# Access Compliance Report

## Public Rights-of-Way

### (Curb Ramps)

Intersection ID: 18381	Main Street: BATHURST_DR	Cross Street: WYALONG_DR	Location:	NE
ADA ID: 07B779246AFE	Ramp Type: Perp	Initial Pass/Fail: Pass	Overall Compliance: No	Severity Score: 5
Codes/Mitigation Info/Possible Solution		Field Measurements/Component Compliance

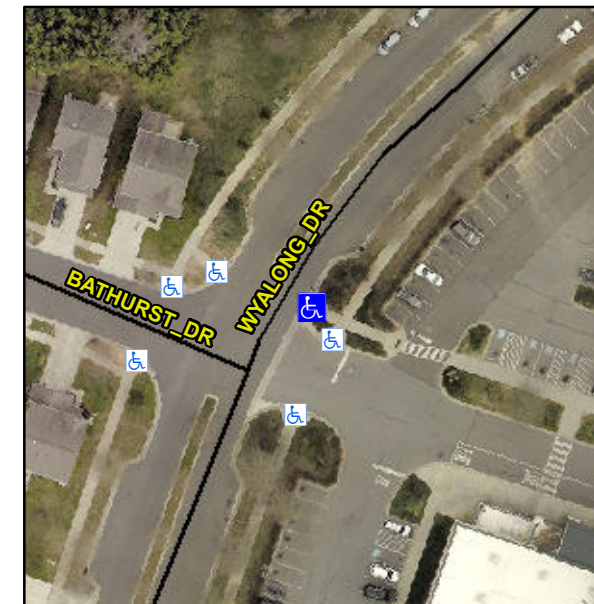
**Not Found, R305.2, R304.5.4**

Compliance	Description	Data	Compliance	Description	Data
N/A	Ramp Length (in)	112.0	Yes	Ramp Slope (%)	6.4
Yes	Ramp Width (in)	48.0	Yes	Ramp XSlope (%)	0.8
N/A	Flare Type LT	Sloped	N/A	Flare Type RT	N/A
N/A	Flare Slope LT (%)	0.7	N/A	Flare Slope RT (%)	3.5
N/A	Flare Traversable LT?	No	N/A	Flare Traversable RT?	No
Yes	Landing Length (in)	91.0	Yes	DWS Provided?	Yes
Yes	Landing Width (in)	48.0	Yes	DWS Contrast?	Yes
Yes	Landing Slope (%)	0.7	Yes	DWS Length (in)	24.5
Yes	Landing X Slope (%)	1.6	Yes	DWS Full Width?	Yes
N/A	Landing Curb? (Y/N)	No	No	DWS Offset (in)	2.5
N/A	Shared Landing?	No			
Yes	Gutter Ponding?	No	No	Gutter Slope (%)	6.8
Yes	Gutter Lip Ht (in)	0.0	Yes	Gutter X Slope (%)	0.4
N/A	Painted X Walk1?	No	N/A	Painted X Walk2?	N/A
	X Walk 1 Direction	To NW		X Walk 2 Direction	N/A
N/A	X Walk 1 Width (in)	N/A	N/A	X Walk 2 Width (in)	N/A
	X Walk 1 Slope (%)	1.3		X Walk 2 Slope (%)	N/A
	X Walk 1 X Slope (%)	1.1		X Walk 2 X Slope (%)	N/A

N/A	Ramp inside XWalk1?	N/A	N/A	Ramp inside XWalk2?	N/A
	Road Slope (%)	N/A	N/A	Clear Space?	Yes
	Road X Slope (%)	N/A	N/A	Clear Space to XWalk (in)	N/A
Yes	Any Obstructions?	No	Yes	Storm Grate/Utility Hazard?	No
	Obstruction Type			Storm Grate/Utility Type	
		N/A			N/A
			Yes	Surface Condition? (G/P)	Good

**Remove & Replace Entire Ramp.  
Remove & Replace Gutter.**
